1. Project Name: Kihei Beach SPP

2. Date of Inspection: January 13, 2005

CONTINUING ELIGIBILITY INSPECTION (CEI) REPORT
FOR HURRICANE & SHORE PROTECTION PROJECTS

KIHEI BEACH, MAUI, HAWAII

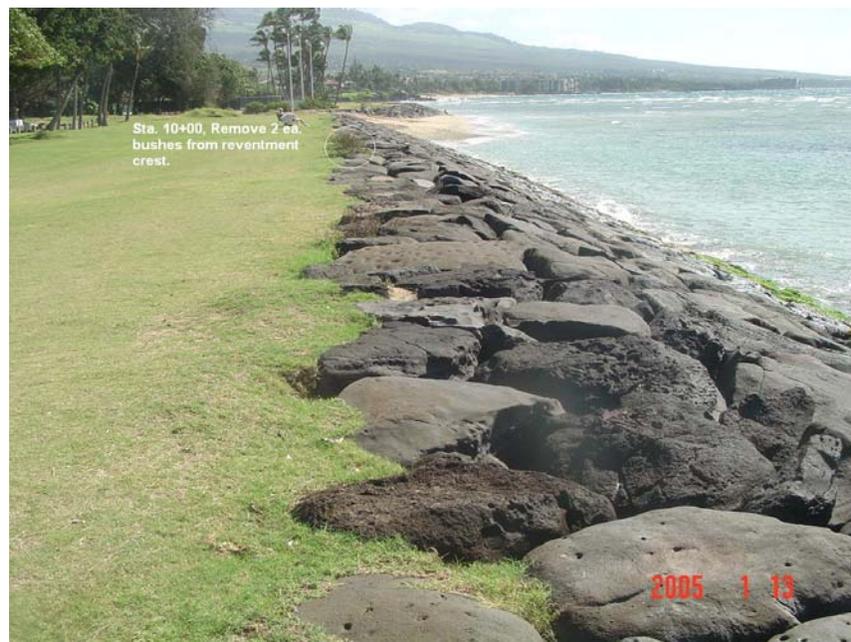
- e. Sta. 3+76, Monitor the area adjacent to cracked armor stone for settling. No Change since FY03. FY04 Photo

Enclosure(s)
Site Plan

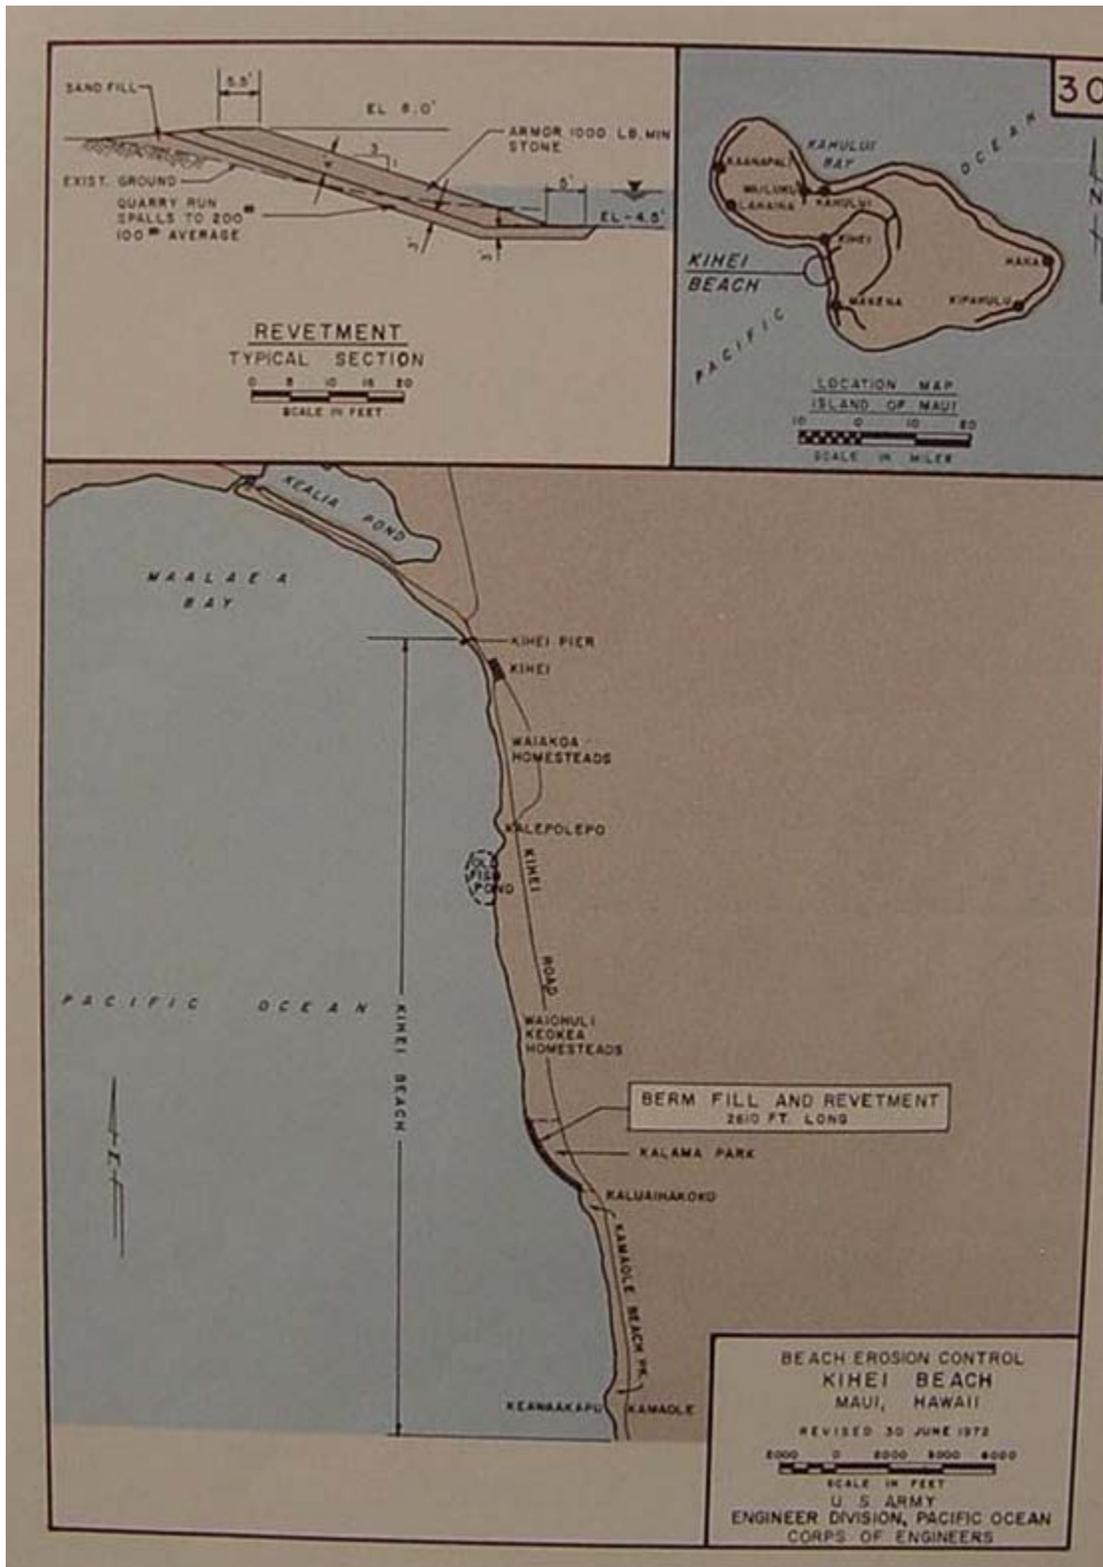
The project consists of a revetment 2,697 LF. The quality and placement of the armor stones is very good. The project begins at Sta. 0+70 (north side) and ends at Sta. 26+97 (south side). The major concerns/deficiencies are as follows:
